Access Compliance Report

Public Rights-of-Way

(Curb Ramps)

Intersection ID: 47270	Main Street: MARVILLE_CT	Cross Street: SAVANNAH_HILLS_DR	Location: NW
ADA ID: 83C85FA6B885	Ramp Type: PerpDiag	Initial Pass/Fail: Fail	Overall Compliance: No
		Severity Score: 25

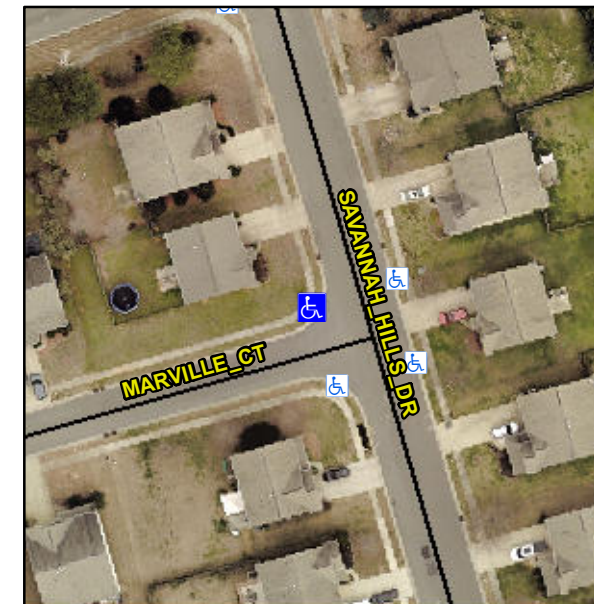
Not Found, R304.5.3

Compliance	Description	Data	Compliance	Description	Data
N/A	Ramp Length (in)	50.0	Yes	Ramp Slope (%)	7.1
Yes	Ramp Width (in)	57.0	No	Ramp XSlope (%)	9.4
N/A	Flare Type LT	N/A	N/A	Flare Type RT	N/A
N/A	Flare Slope LT (%)	N/A	N/A	Flare Slope RT (%)	N/A
N/A	Flare Traversable LT?	N/A	N/A	Flare Traversable RT?	N/A
N/A	Landing Length (in)	N/A	N/A	DWS Provided?	N/A
N/A	Landing Width (in)	N/A	N/A	DWS Contrast?	N/A
N/A	Landing Slope (%)	N/A	N/A	DWS Length (in)	N/A
N/A	Landing X Slope (%)	N/A	N/A	DWS Full Width?	N/A
N/A	Landing Curb? (Y/N)	N/A	N/A	DWS Offset (in)	N/A
N/A	Shared Landing?	N/A			
N/A	Gutter Ponding?	N/A	N/A	Gutter Slope (%)	N/A
N/A	Gutter Lip Ht (in)	N/A	N/A	Gutter X Slope (%)	N/A
N/A	Painted X Walk1?	No	N/A	Painted X Walk2?	No
	X Walk 1 Direction	To S		X Walk 2 Direction	To E
N/A	X Walk 1 Width (in)	N/A	N/A	X Walk 2 Width (in)	N/A
	X Walk 1 Slope (%)	2.2		X Walk 2 Slope (%)	6.5
	X Walk 1 X Slope (%)	5.7		X Walk 2 X Slope (%)	4.0

Remove & Replace Curb Ramp With Two New Directional Ramps or Equivalent.
